FORMER ELEMENTARY SITE PARK PLAN **CITY OF DETROIT, OREGON**

SEPTEMBER, 2013

Community
Planning
Workshop

Figure 1 2.2. Organic concept poster

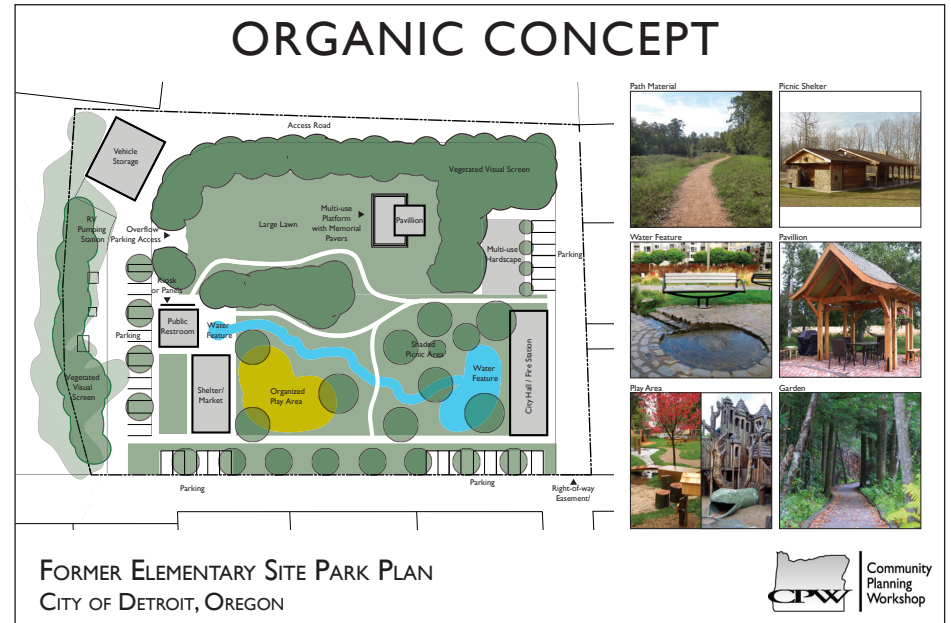
- Organic play area building is scary!
- Plaza is too urban feeling.
- Who manages the RV pumping station? Do we need it?
- No RV dumping, please.
- Need electricity in pavilion.
- No sand in the play area—becomes kitty litter!
- Wood playground would not hold up to weather.
- Not the stone pavilion.

Figure 13. Conceptual plan drawing

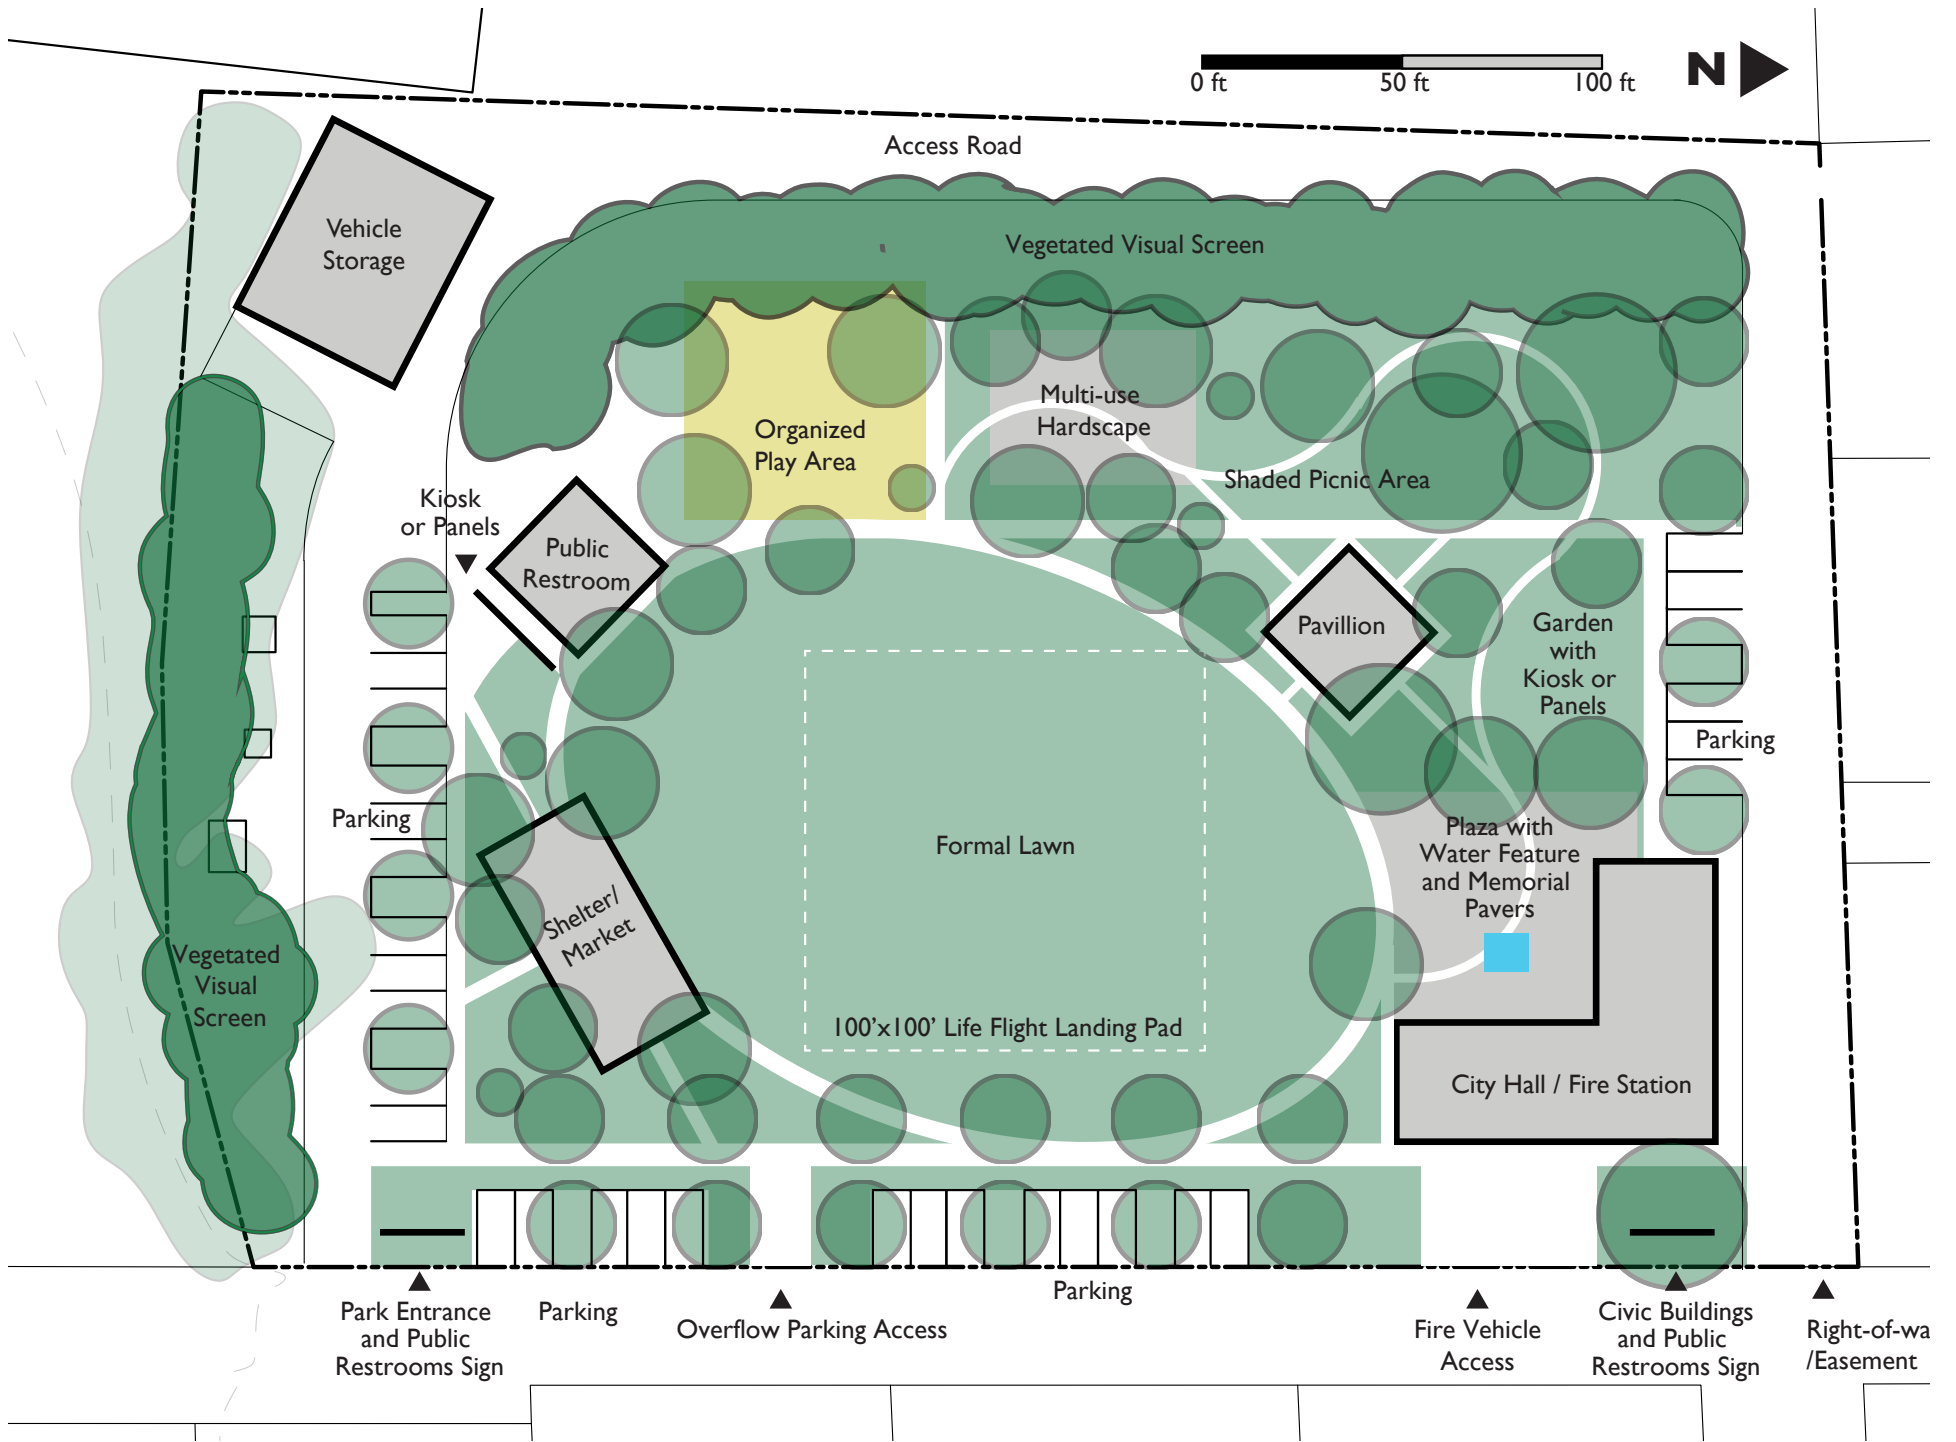
Both the Detroit Park Commission and City Council expressed overall satisfaction with the park design concept. CPW received the following feedback for changes or additions to the design and program:

- The multi-use hardscape element should include a basketball hoop.
- There should not be a separate skate-park element but the plaza should be designed to accommodate, not repel, skateboard users.
- Electrical outlets should be available throughout the site to accommodate community events.
- The location of the public restrooms should be moved to the southeast corner to most easily accommodate the needs of motorists. The location should be swapped with the location of the picnic/market shelter.
